Hexham Train Support Facility

*State Significant
Infrastructure Modification
Assessment
(SSI 6090 MOD 1)*

October 2019

Figure 4 | Location of proposed culverts (Source: BMT, 2019)

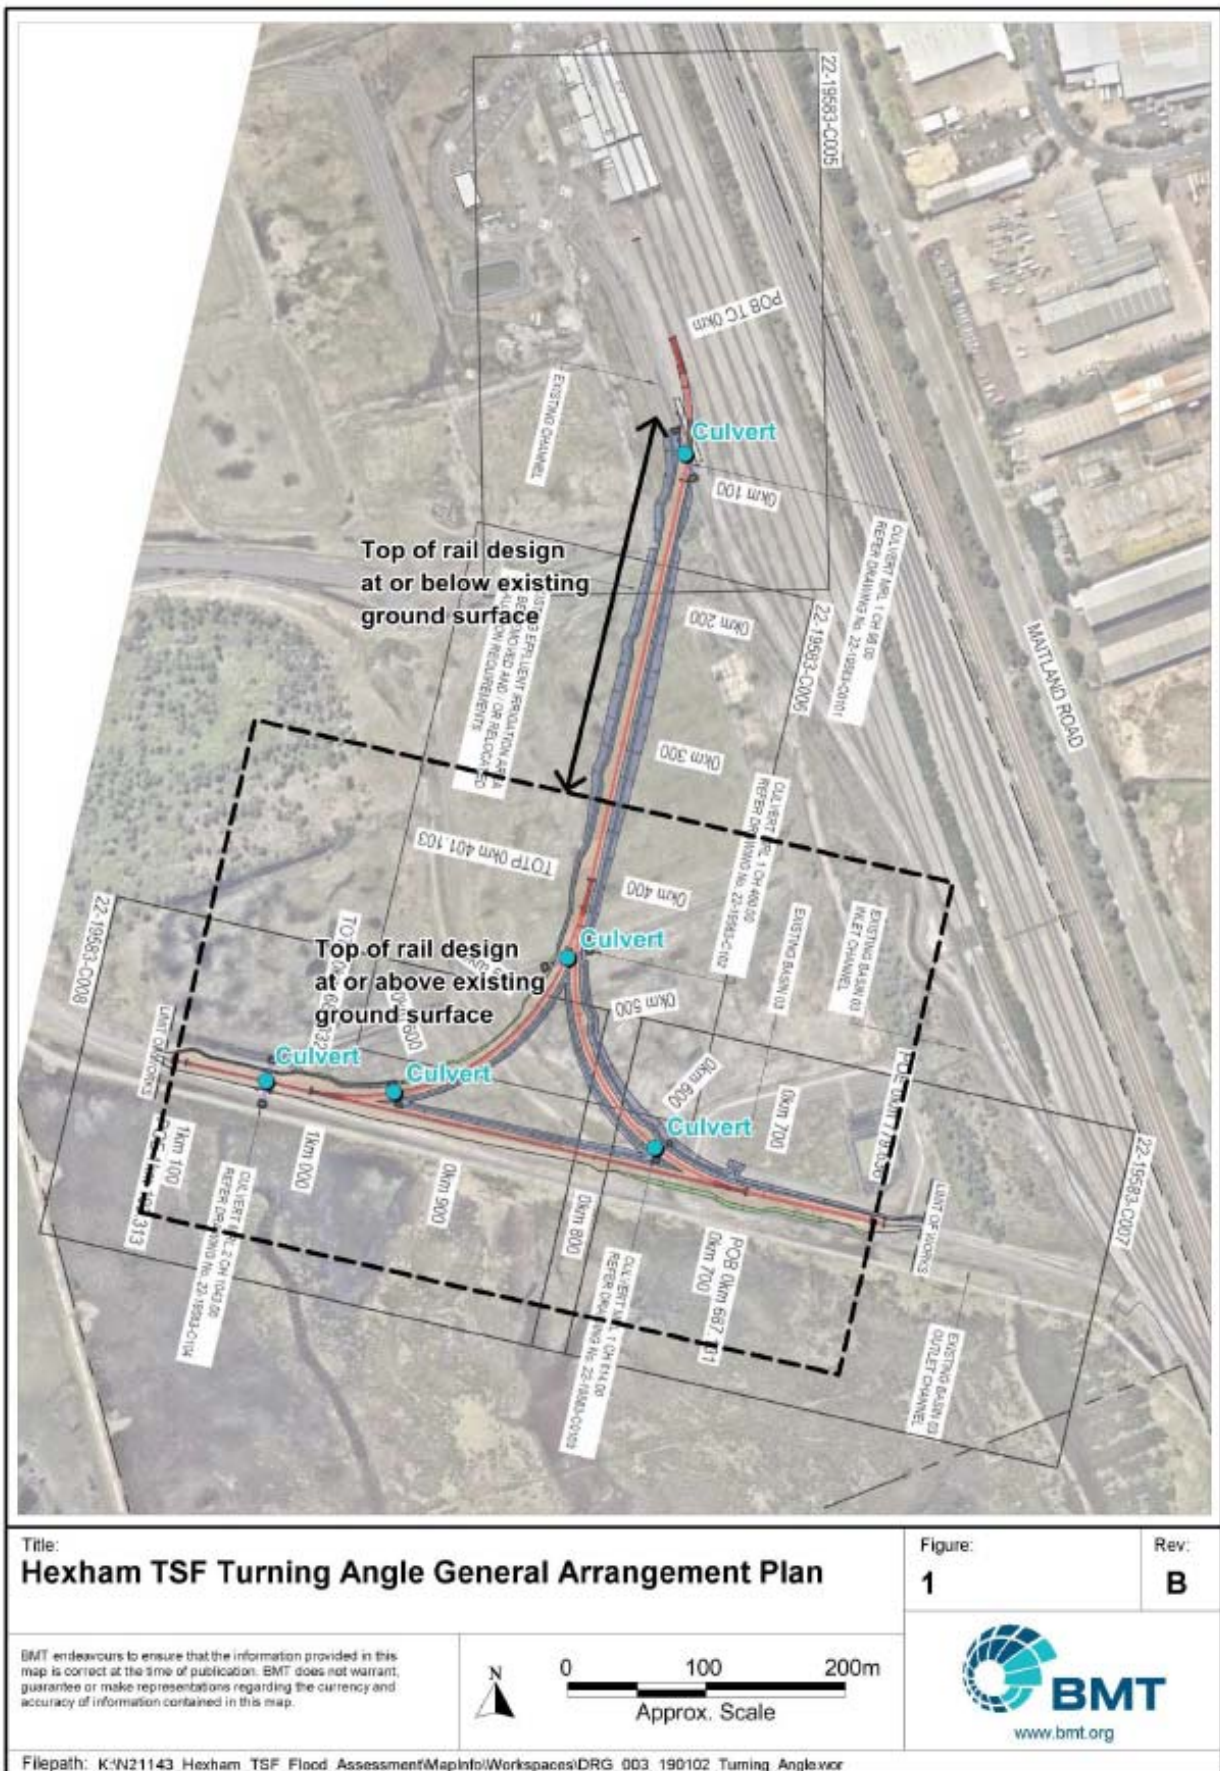
During a 1% AEP and rarer flood events, a minor flow path crosses the coal tailings area, within the modification footprint, towards the Hunter River to the east. The turning angle would obstruct this flow path downstream. Flood waters will generally be conveyed through the proposed culverts, beneath the rail tracks, as shown in **Figure 4**.

However, during 1% AEP events, the proposed modification would alter flow paths. The flow of floodwater would be limited to the proposed box culverts, thereby reducing the downstream flooding to the east of the turning angle. This would result in a minor redistribution of flood flow to the Hexham Swamp flow path at the southern end of the site. The Department acknowledges that the distribution of flows would be localised and would represent an approximate increase of 1% of flows along the Hexham Swamp flow path. The Department accepts the Proponent's conclusion that this localised redistribution of flows would not have a significant impact on downstream velocity and scour potential.

The Department is satisfied that the changes to floodwater behaviour would not cause a significant change to the existing, and approved, flood regimes in the locality. This is supported by submissions received from ARTC and the City of Newcastle. The Department acknowledges that the existing infrastructure approval includes a number of conditions to minimise the flood risk of the approved project. These conditions include:
